Access Compliance Report Public Rights-of-Way (Curb Ramps)

Main Street: SHAKESPEARE_DR Cross Street: BASKERVILLE_RD Location: S

ADA ID: RPAT211202094100 Ramp Type: Type 1 - Perpendicular Diagonal Initial Pass/Fail: Pass Overall Compliance: No Severity Score: 21

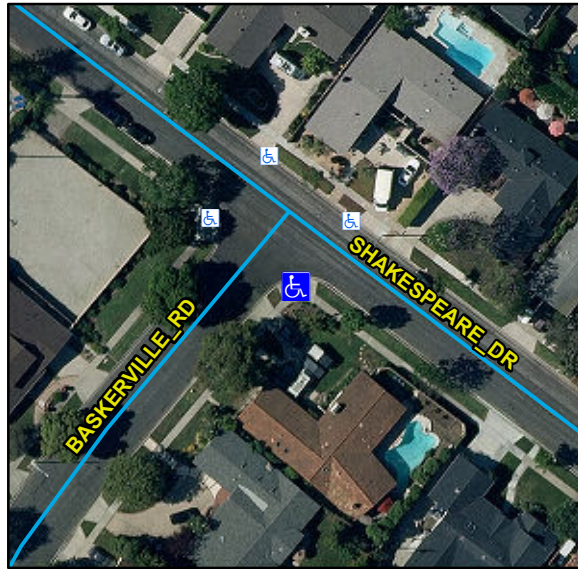
Compliance	Description	Data	Compliance	Description	Data
N/A	Ramp Length (in)	94	N/A	Flare Type LT	
Yes	Ramp Width (in)	48			Sloped
Yes	Ramp Run Slope (%)	5.8	N/A	Flare Slope LT (%)	6.7
Yes	Ramp Cross Slope (%)	0.3	N/A	Flare Traversable LT	No
N/A	Landing Present	Yes	N/A	Flare Type RT	
N/A	Landing Length (in)	30			Sloped
Yes	Landing Width (in)	57	N/A	Flare Slope RT (%)	4.9
Yes	Landing Run Slope (%)	1.5	N/A	Flare Traversable RT	No
Yes	Landing Cross Slope (%)	0.5	No	DWS Provided	No
N/A	Landing Movement Obstructed?	No	N/A	DWS Contrast	N/A
	Landing Movement Type	N/A	N/A	DWS Length (in)	N/A
N/A	Landing Shared	No	N/A	DWS Full Width	N/A
N/A	Clear Space	Yes	N/A	DWS Offset Left (in)	N/A
N/A	Clear Space To Crosswalk (in)	48	N/A	DWS Offset Right (in)	N/A
N/A	Marked Crosswalk 1	No	N/A	Marked Crosswalk 2	No
	Crossing 1 Direction	NE		Crossing 2 Direction	NW
	Marked Crosswalk 1 Width (in)	N/A		Marked Crosswalk 2 Width (in)	N/A

N/A	Ramp Inside Crosswalk 1	N/A	Yes	Ramp Inside Crosswalk 2	N/A
	Crossing 1 Slope (%)	4.8		Crossing 2 Slope (%)	3.2
	Crossing 1 Cross Slope (%)	1.2		Crossing 2 Cross Slope (%)	1.2
Yes	Gutter Ponding	No	Yes	Curb Slope	3.6
Yes	Gutter Lip Height (in)	0		Road Run Slope (%)	0.9
No	Gutter Run Slope (%)	10.5		Road Cross Slope (%)	2.9
Yes	Gutter Cross Slope (%)	1			
Yes	Overall Surface Condition: Acceptable		No	Perp Joint Present	No
	Cross Gutter Present?	No		Spandrel Present?	No
	Replace Cross Gutter?	N/A		Replace Spandrel?	N/A

Remove & Replace Curb Ramp With Two New Directional Ramps or Equivalent. Remove & Replace Gutter.
